## STAFF REPORT

**Planning Commission**

**Staff Report Number:** 18-085-PC

**Study Session:** Study Session/Sagar Patel/1704 El Camino Real

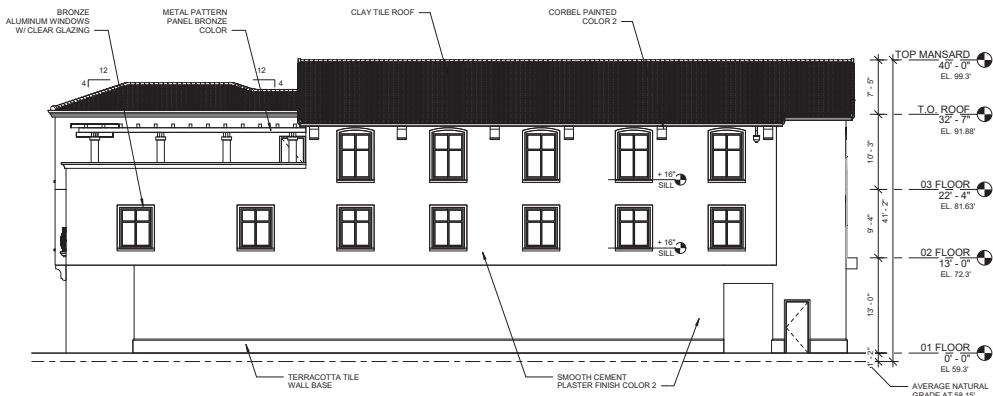
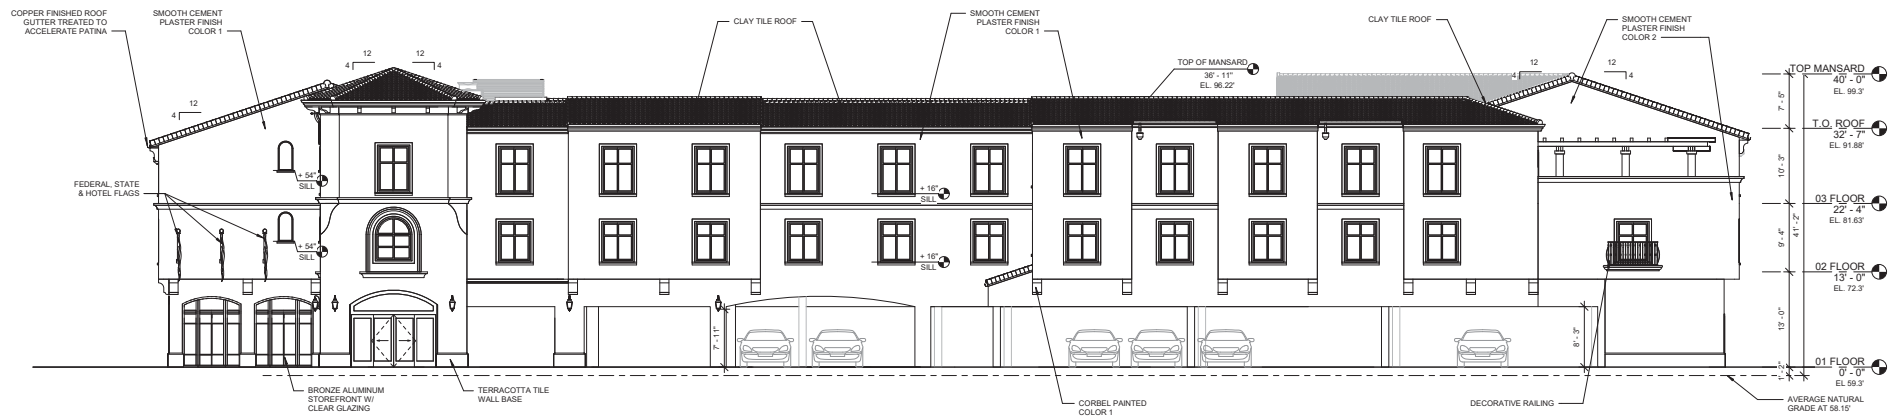
- E.3.4.1 (Building Breaks): Based on Planning Commissioners' comments at the Study Session that the minor façade modulation does not apply since the west elevation is over 130 feet from El Camino Real, staff believes the building break requirement similarly does not apply. (Both the proposal submitted in March and the current proposal would not be in compliance if the building breaks or minor façade modulation were applied to the west elevation.)

- E.3.4.2.01 (Minor Façade Modulation Standard): This standard does not apply as described above.
- E.3.5.08 (Architectural Projections Guideline): This guideline states that architectural projections like canopies and awnings should be integrated with the ground floor and overall building design to break up the mass, to add visual interest to the building, and provide shelter and shade. The previous staff report noted that the porte-cochere proposed at that time did add a massing element to break up the mass; however, the report also noted that the form did not seem well integrated with the ground floor or overall building design. The porte-cochere has now been removed and replaced with patio space underneath the tower where the entry is located.

Similar to the minor façade modulation standard, staff believes the west elevation would not be subject to the building profile requirement (E.3.4.3) since it is over 130 feet from El Camino Real. It appears the applicant's alternative proposal, depicted on the last seven sheets of the plan set, may not be in compliance if the building profile were applied to the west elevation.

EAST NEIGHBOR PHOTO SIMULATION

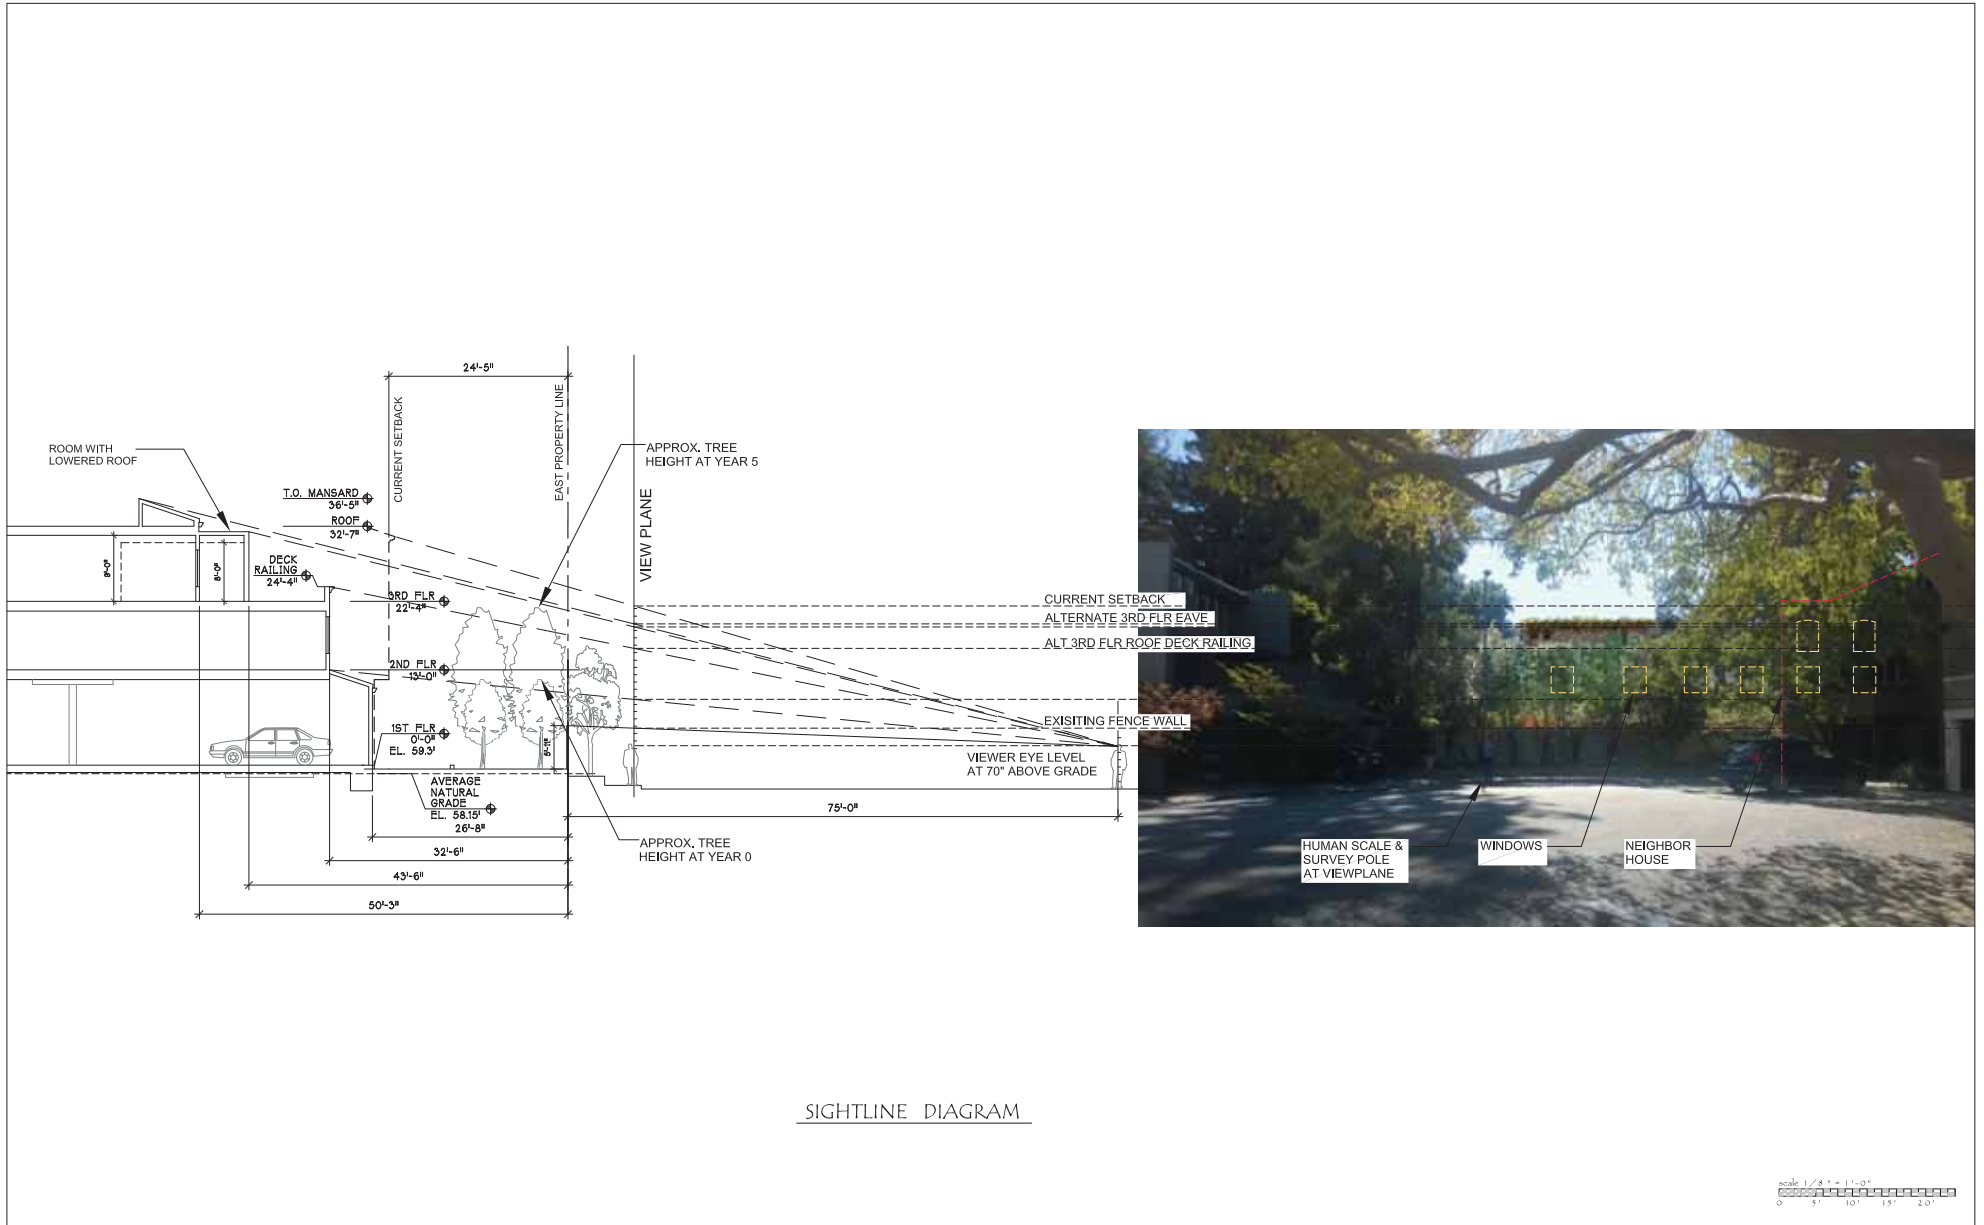
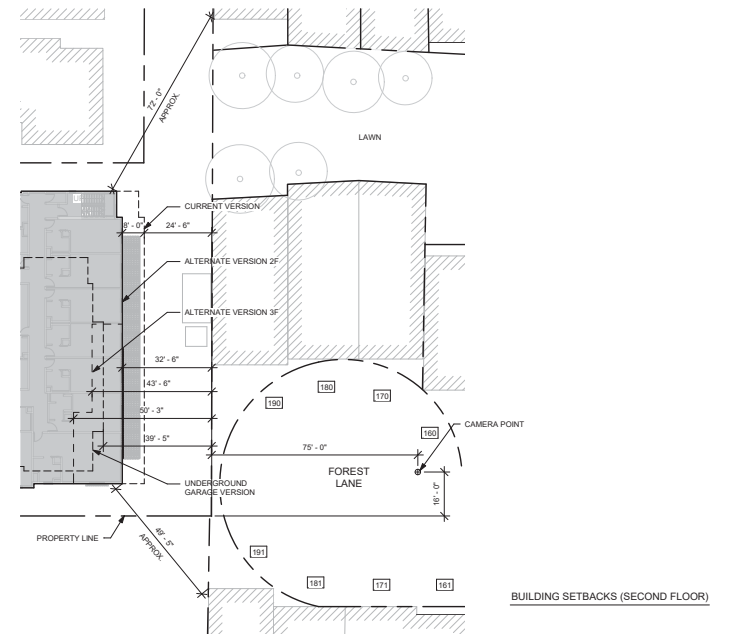
Recently the applicant has developed an alternative proposal to address concerns of neighboring property owners to the east. The main plan set shows a rear setback along the eastern property line of approximately 24 feet, five inches, while the alternative proposal included as the last seven plan sheets, shows a site layout where the proposed hotel is shifted west, resulting in a rear setback of slightly over 26 feet, seven inches on the first floor and slightly over 32 feet, seven inches on the second and third floors. The alternate proposal also includes the re-orientation of two, third story, formerly east-facing rooms towards the south, resulting in a larger roof deck, as well as a slightly lower building height in the southeast corner due to the elimination of a previously proposed mansard feature. The applicant’s project description letters, explaining the revisions since the study session as well as the alternative proposal are included as Attachment D, and the project plans (including the alternative proposal, located at the end) are included as Attachments E.

Adjacent neighbors of the proposed hotel are concerned that the current design has gone much closer to the easterly property line than the previously reviewed design. This change in the eastern setback distance is due primarily to the redesign of the hotel when recent estimate of construction cost increased dramatically, making the underground parking garage cost prohibitive for a hotel with a relatively low room count. The current design will actually make the project smaller (FAR 1.047 versus 1.088) and the construction schedule shorter by at least two months with far less truck traffic by eliminating the export of excavated soil for the underground garage.

The current proposal brought all car parking above ground towards the easterly half of the site. The western half of the ground floor remains as the lobby, public large group areas and back-of-house functions. To keep the number of guestrooms the same, the building is lengthened primarily towards the east and widened towards the north & south sides. To make room for the garage on grade, the courtyard and pool deck have been relocated to the 2<sup>nd</sup> level and the swimming pool replaced by a smaller jacuzzi pool. Similar to the previous scheme, this courtyard opens to the north but is screened from that side with an 8-foot, decorative and acoustical privacy fence.
